GENTHERM PATIO PERGOLA AND COVERED PATHWAY JSP24-19

Approval of the request of Brian Hughes of Northern Equities Group on behalf of Gentherm for a Section 9 Façade waiver. The subject parcel is 5.94 acres and is located at 28875 Cabot Drive in the Haggerty Corridor Corporate Park in the OST, Office Service Technology district. The request is to construct a wooden pergola and covered pathway on the patio at the rear of the building.

FAÇADE REVIEW

Re: **FACADE ORDINANCE**
Gentherm Patio, JSP24-19,
 Façade Region: 1, Zoning District: OST

SHEET NUMBER:
A-511

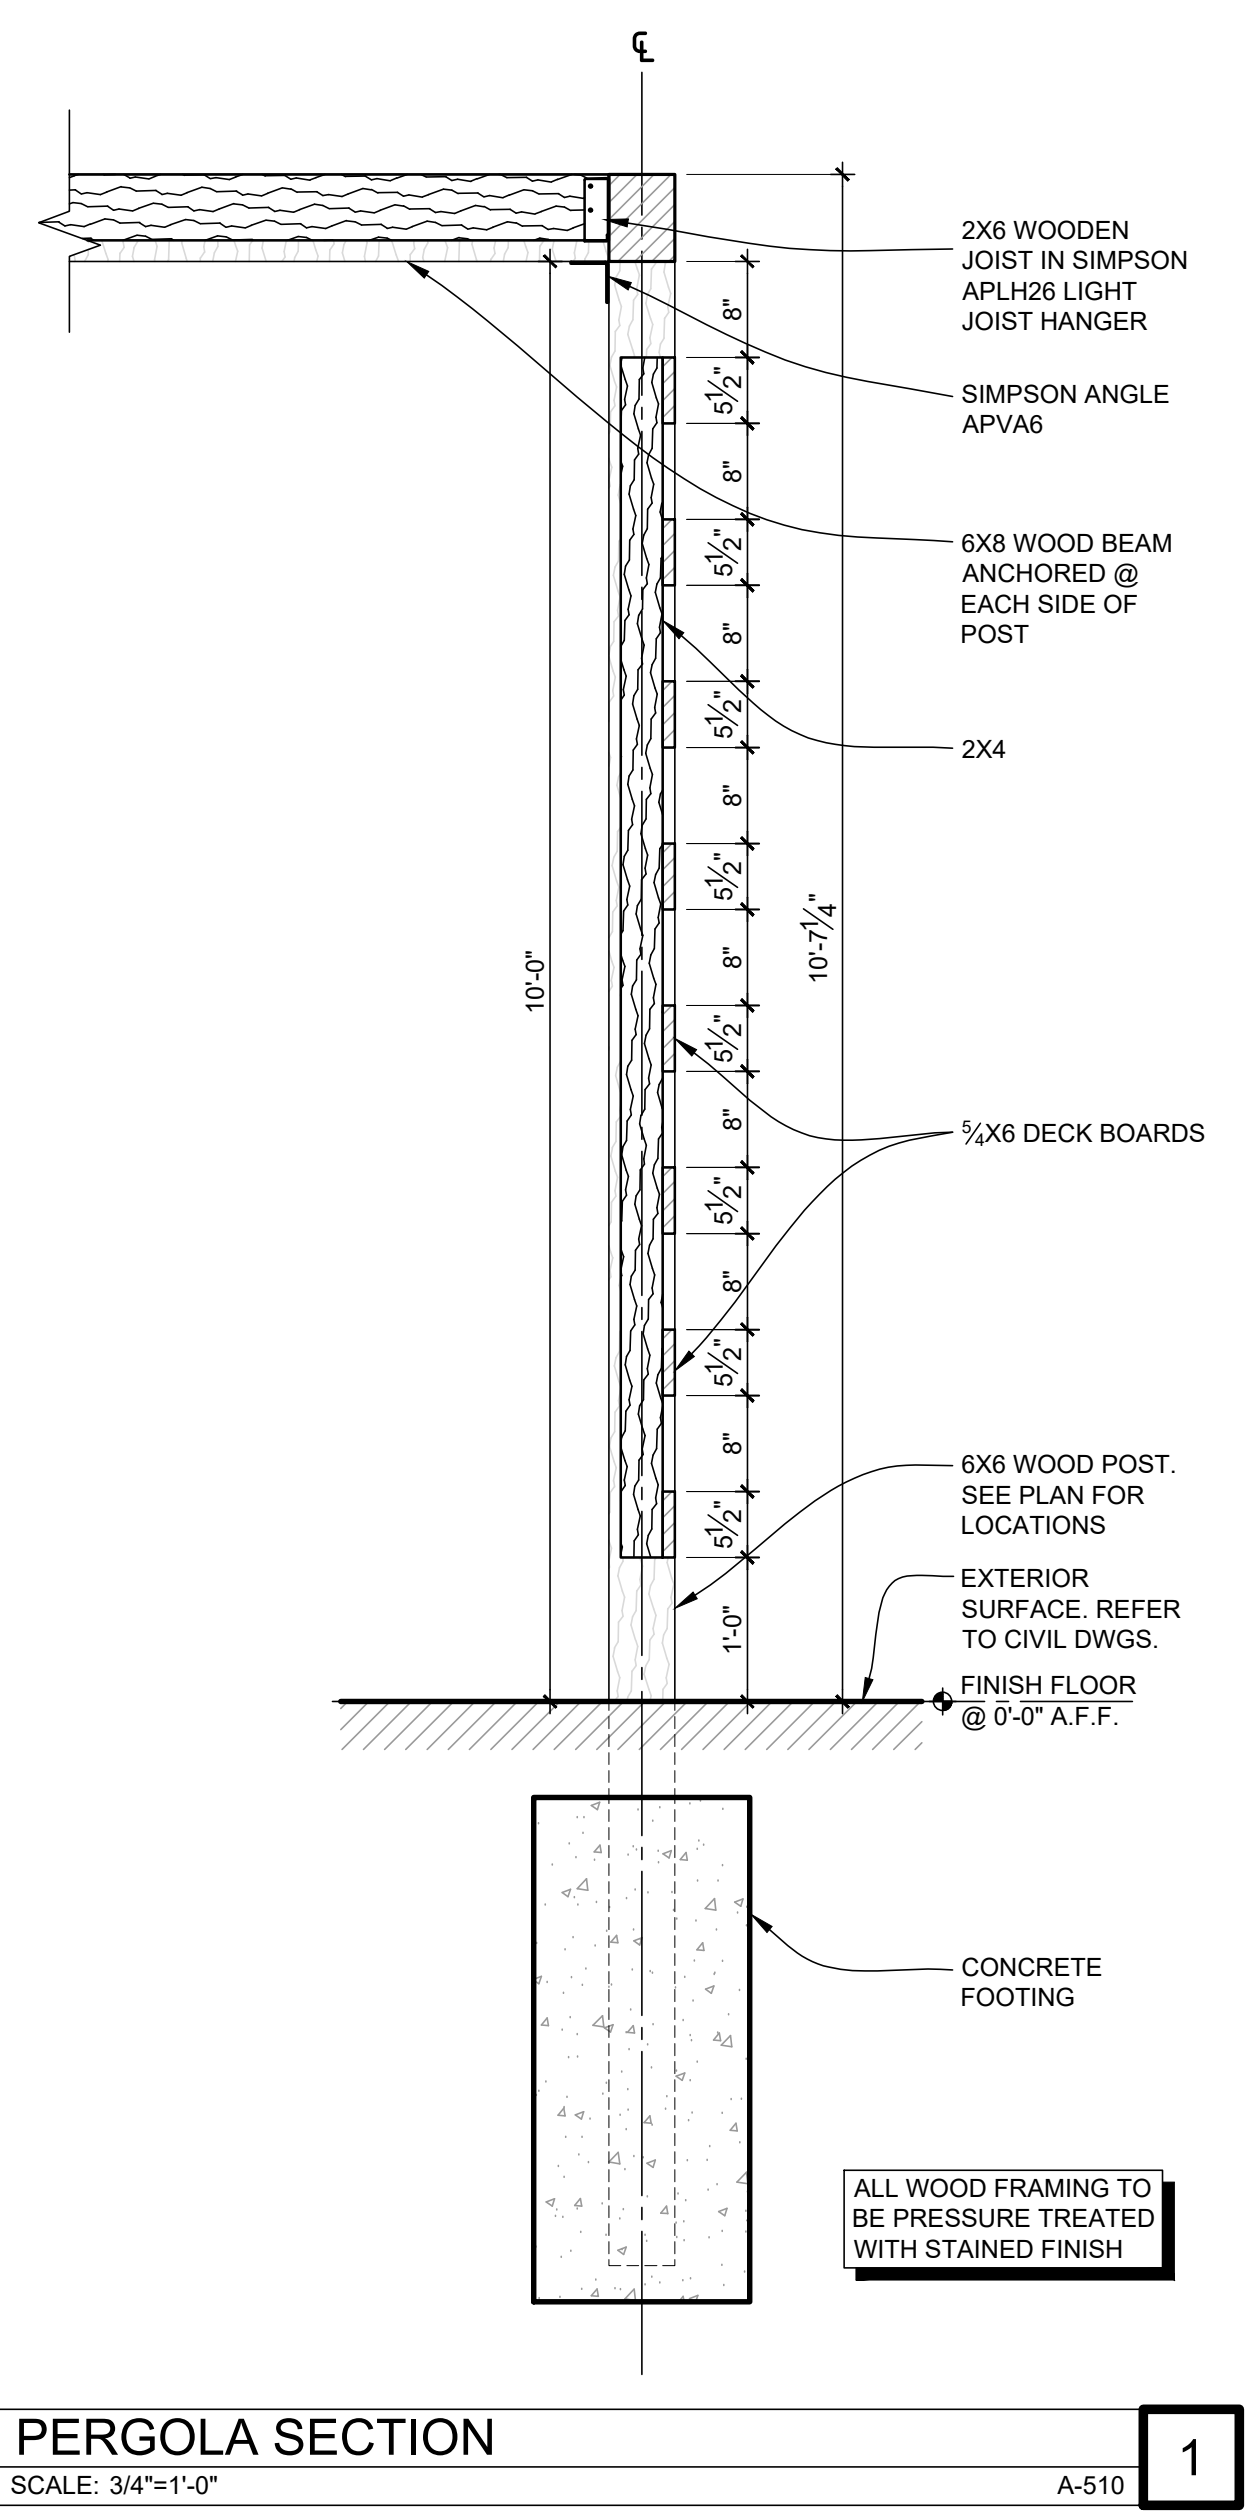
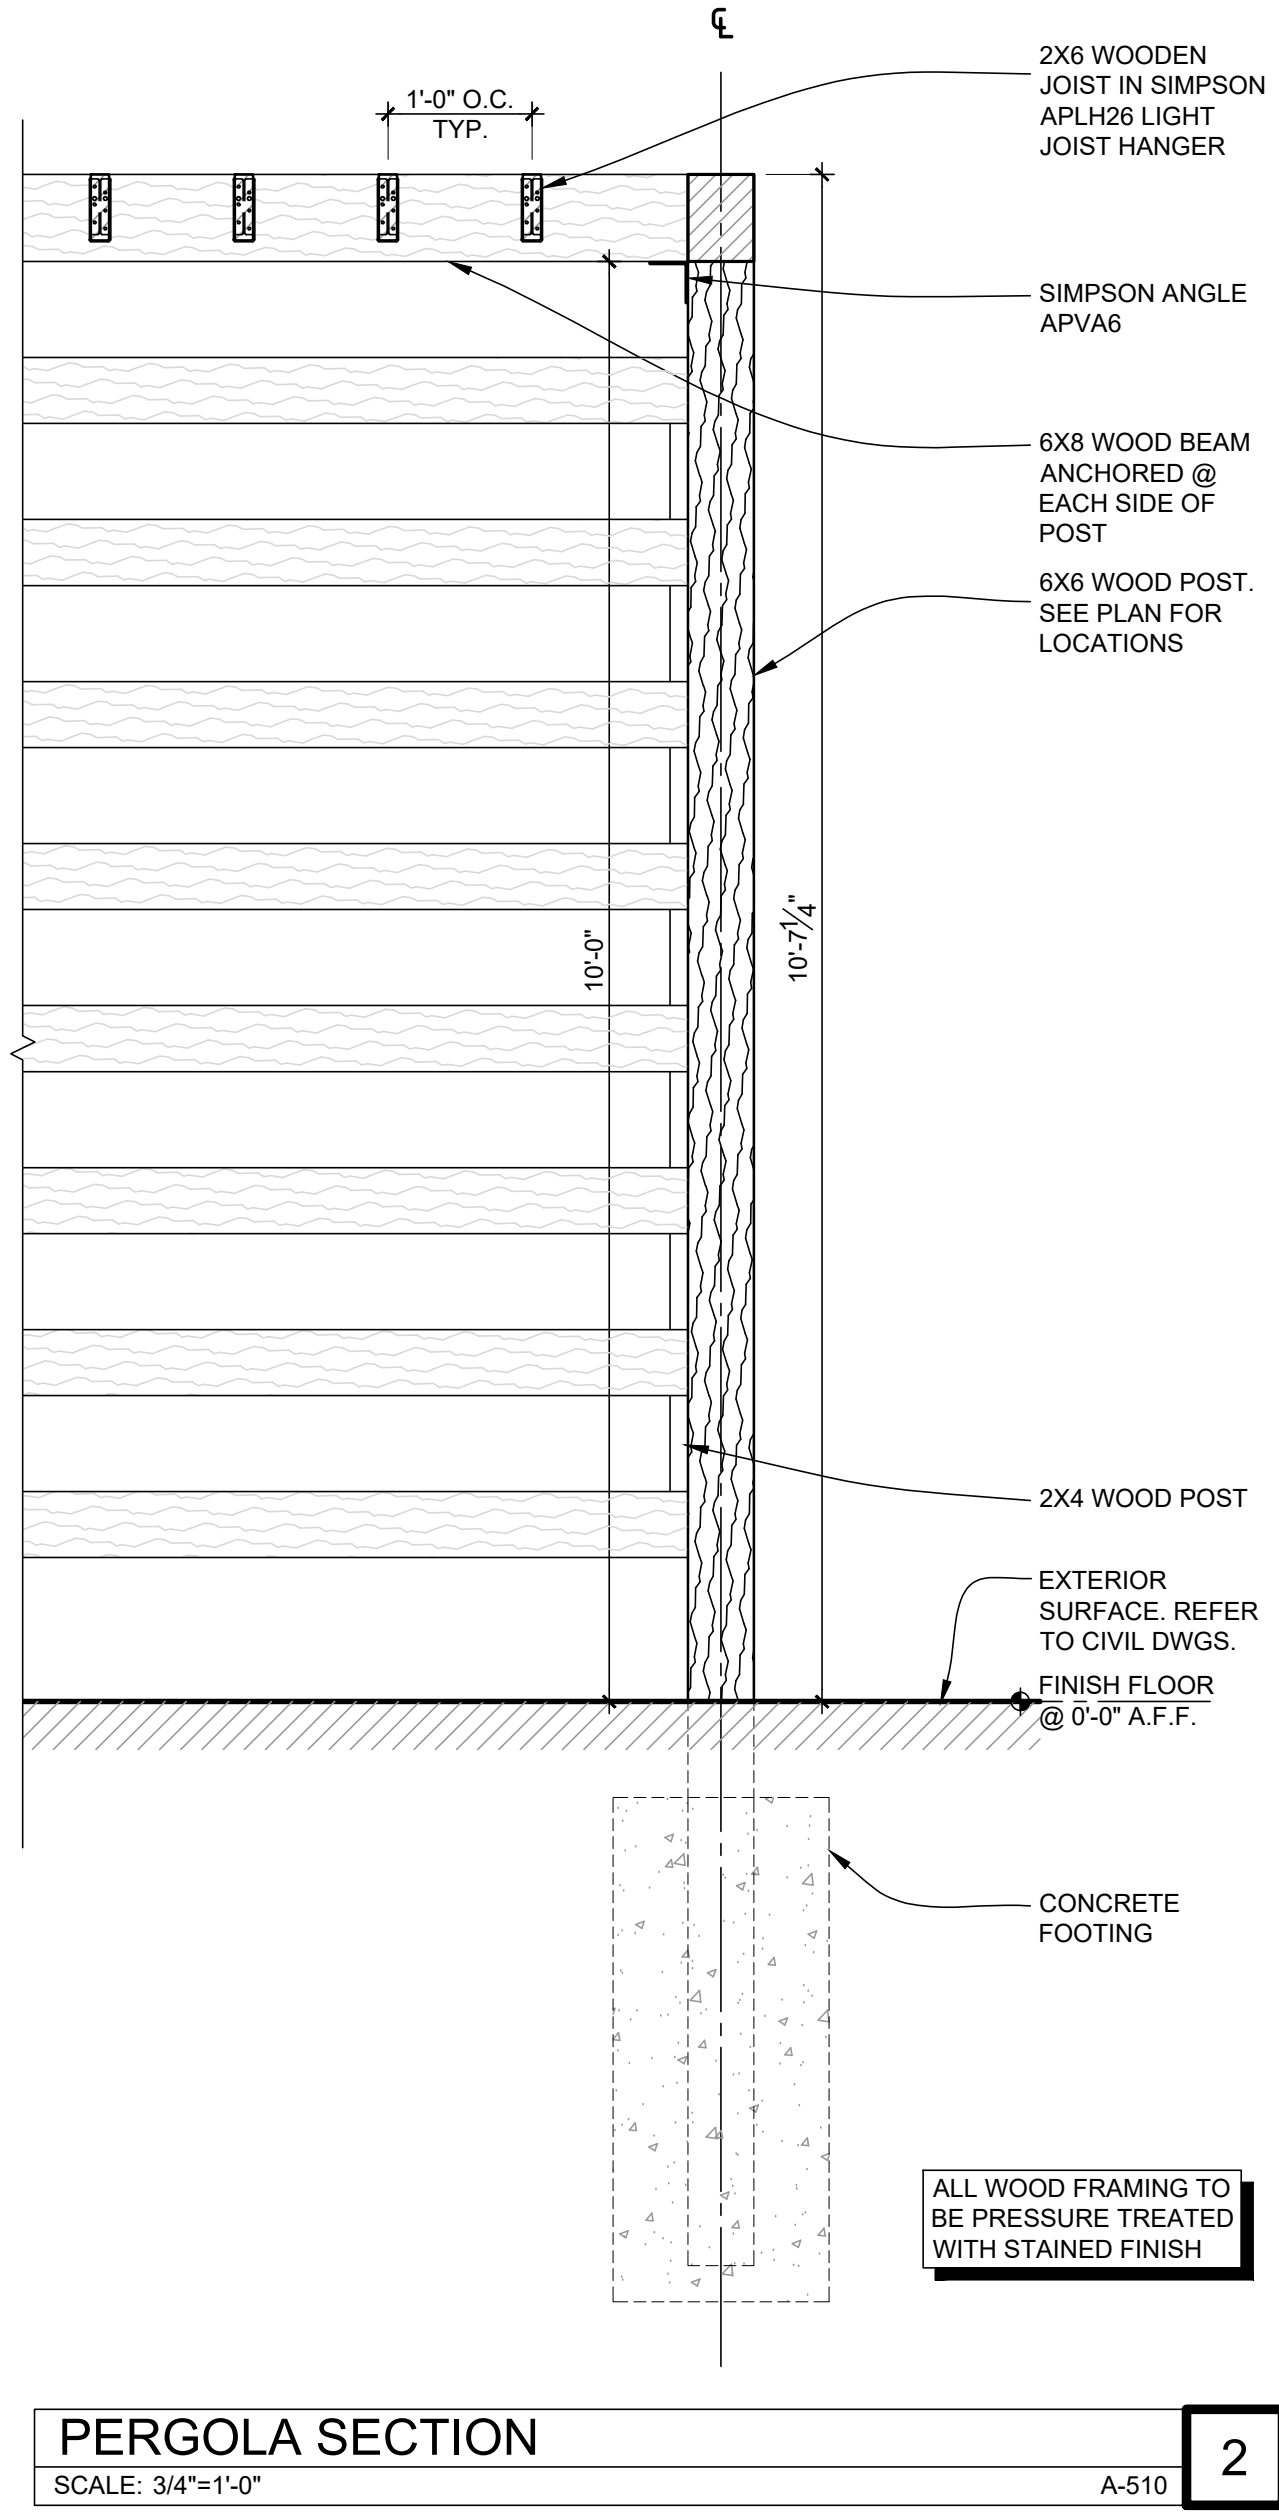
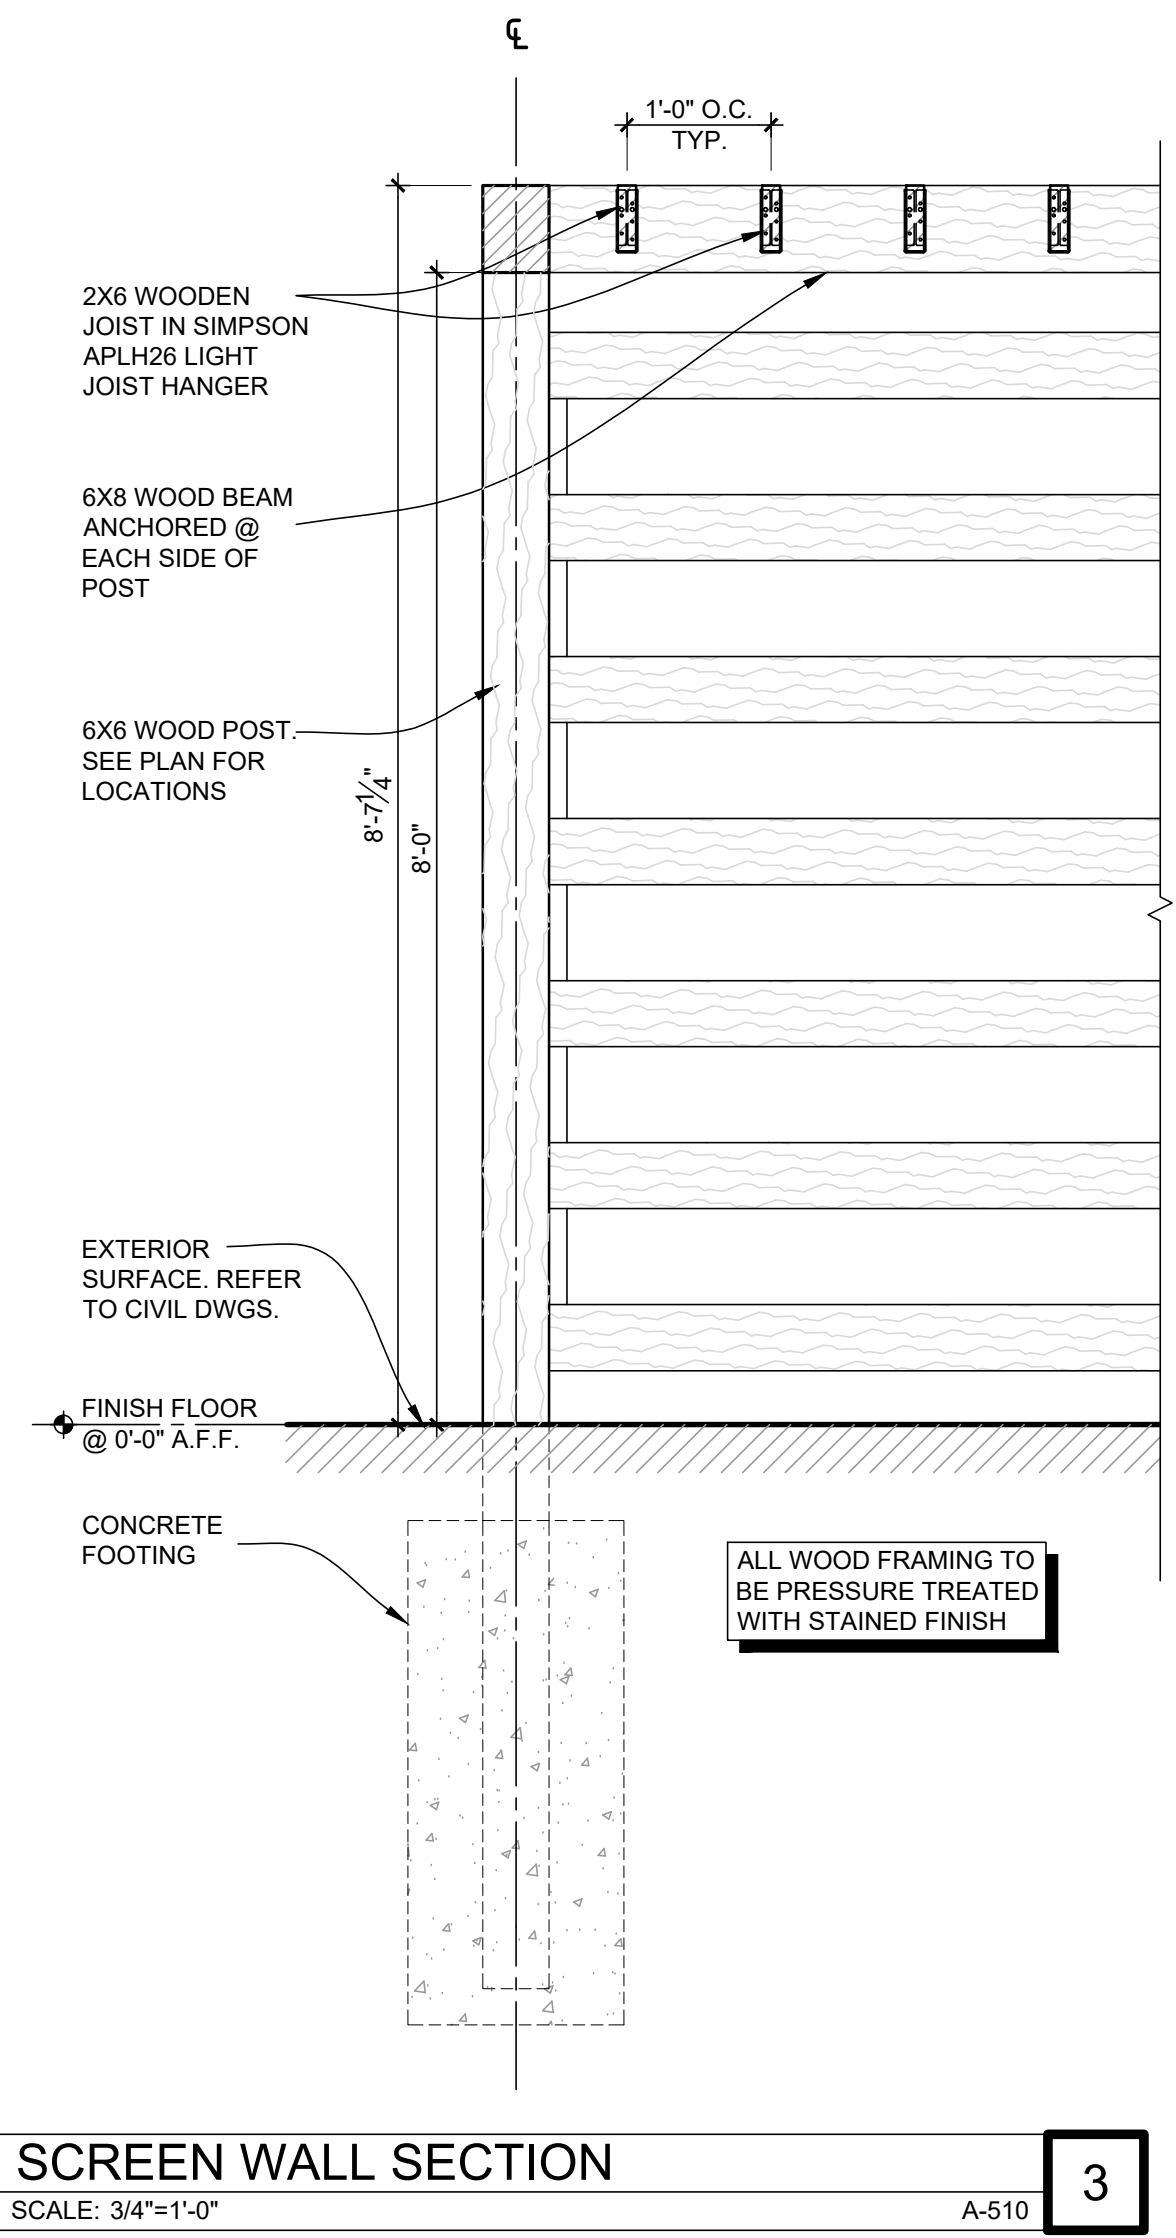
The following Façade Review is based on the drawings prepared by F.A. Studio Architects, dated 11/7/24. The percentages of materials for each façade are shown on the table below. The maximum and minimum percentages required by the Façade Ordinance are shown in the right-hand column. As shown below, all proposed materials are in non-compliance with the Ordinance.

South (Front)	North	East	West	Ordinance Maximum
Natural Wood w/ Stain Finish	100%	100%	100%	100%	0%

The proposed pergola structures are considered a canopy as described in Section 5.15.12 of the Façade Ordinance. The Ordinance requires that not less than 30% of the façade materials used on canopies be identical to the primary building. In this case the primary building is Brick. The proposed structures are constructed entirely of natural stained wood. Therefore, a Section 9 Waiver would be required for this deviation.

Recommendation - In this case the proposed structures will not be visible for Cabot Drive of the M-5 highway. Therefore, we recommend that the proposed structures are consistent with the intent and purpose of the Façade Ordinance and that a Section 9 Waiver be granted for the underage of brick and overage of stained wood.
